10-31-24 CLARIFICATION:
PAGE: 1 OF 1
RE: UNNEEDED STUD
COLUMN REFERENCE
NUMBER.

FIRST FLOOR - ELEVATION 'D'

Wilson
Garage Left

S-2.1

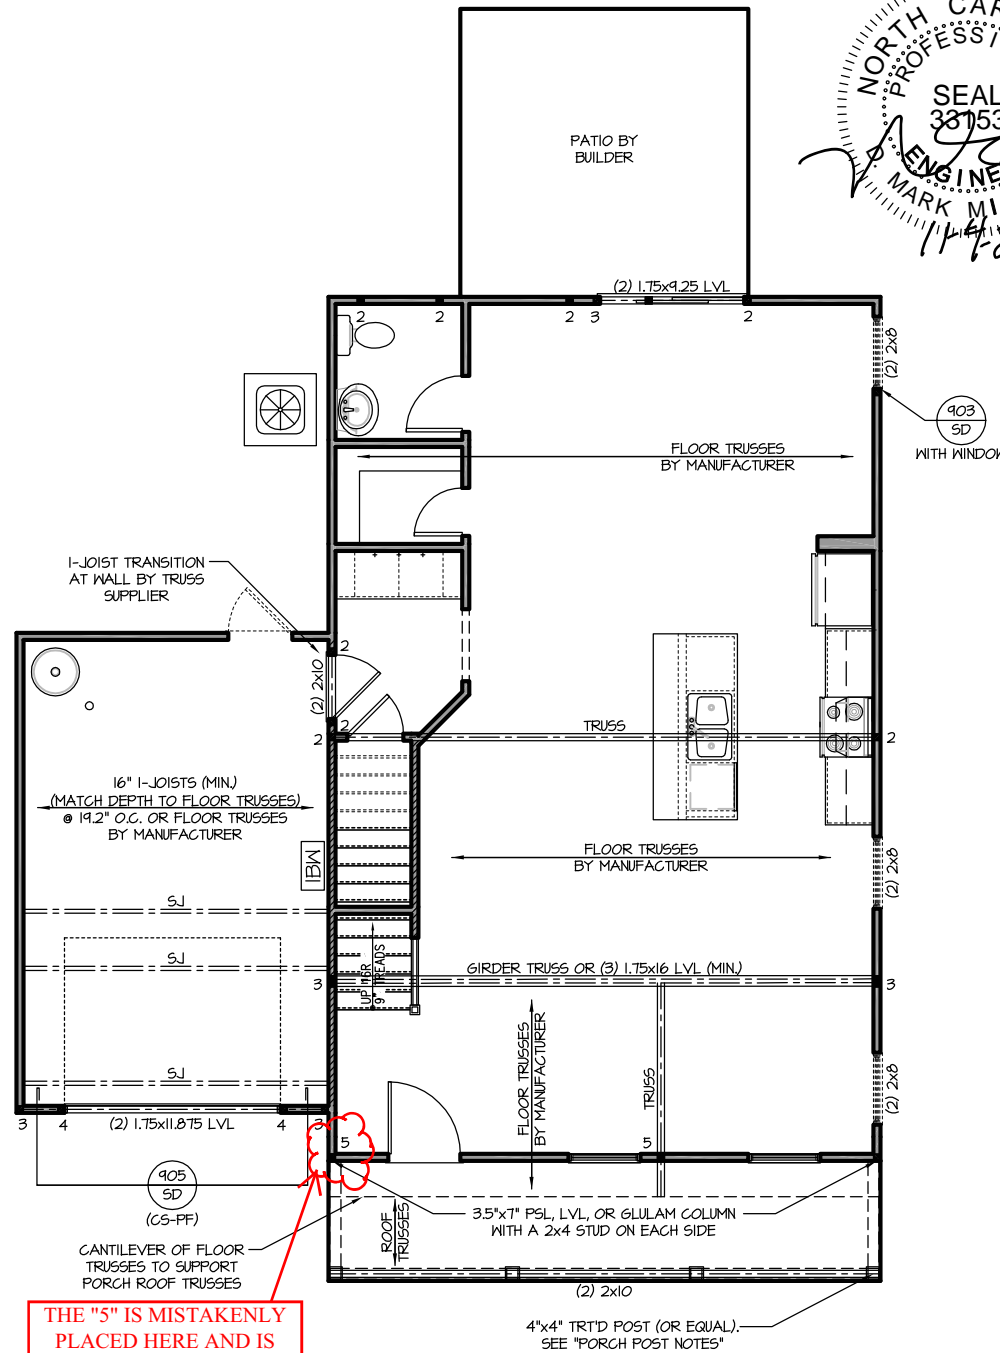
THE "5" IS MISTAKENLY
PLACED HERE AND IS
NOT NEEDED.
